UNITED STATES PATENT AND TRADEMARK OFFICE

Office Action Summary

10/537,812

EGERTER ET AL.

ATTACHMENT 1

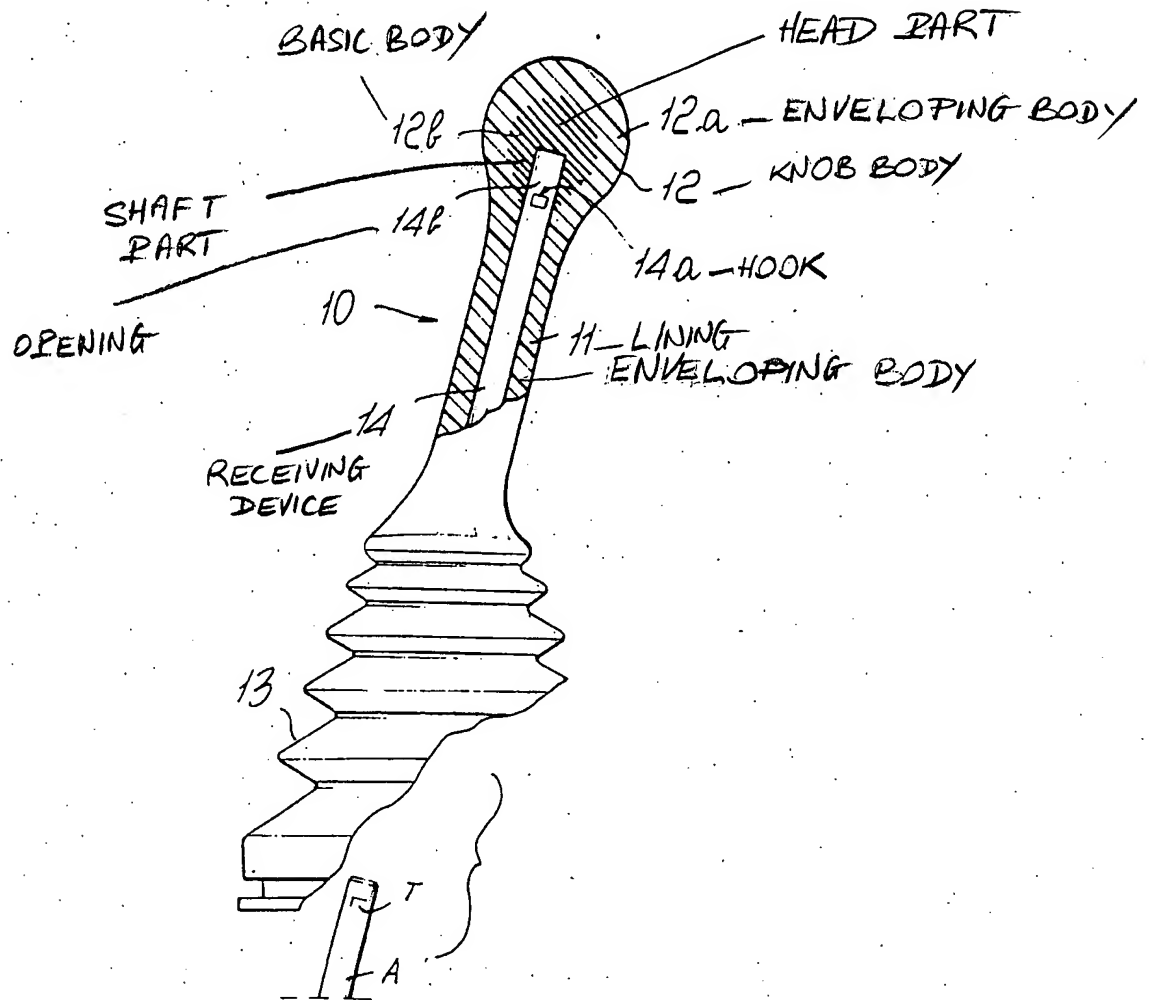
Regarding claim 14, the knob body 12 has a basic body 12b with a shaft part (see Attachment 1 hereinafter "Att. 1") and a head part (Att. 1) which are surrounded at least partially by an elastically constructed enveloping body 12a, 11 and wherein openings 14b are provided in a lateral surface of the shaft part (Att. 1) and are penetrated by sections of the enveloping body 12a, 11. *Ibid.* col. 2, lines 25-66 and claims 1-8.

Regarding claim 15, the openings 14b extend in axial and circumferential directions of the shaft part (Att. 1).

Regarding claims 18 and 28, a detent device for axially fixing the knob 10 on the control lever A is provided in the head part (Att. 1) of the basic body 12b.

Regarding claim 14, the knob body 12 has a basic body 150, 151 with a shaft part (Att. 2) and a head part (Att. 2) which are surrounded at least partially by an elastically constructed enveloping body 11 and wherein openings 152 (FIG. 4) are provided in a lateral surface of the shaft part (Att. 2) and are penetrated by sections of the enveloping body 11.

Regarding claim 15, the openings 152 extend in axial and circumferential directions of the shaft part (Att. 2).

Regarding claims 21 and 31, outer ribs 120 extending from the shaft part (Att. 2) to the head part (Att. 2) are provided for anchoring the enveloping body 11.
